Atty. Docket No. PIA31222/DBE/US  
Serial No: 10/751,199

**Amendments to the Drawings**

### **REMARKS/ARGUMENTS**

**FIG. 1**

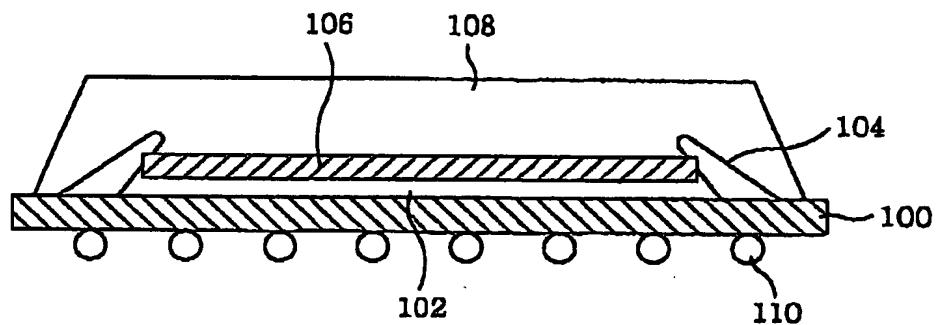
The attached sheet of drawings includes changes to Fig. 1. This sheet, which includes Figs. 1-2, replaces the original sheet including Figs. 1-2. In Fig. 1, the legend "Prior Art" is added as required by the Examiner.

Fig. 1 has been amended to overcome the Examiner's objection to the drawings without adding any new matter and in full compliance with statutory and regulatory requirements.

(PRIOR ART) — added
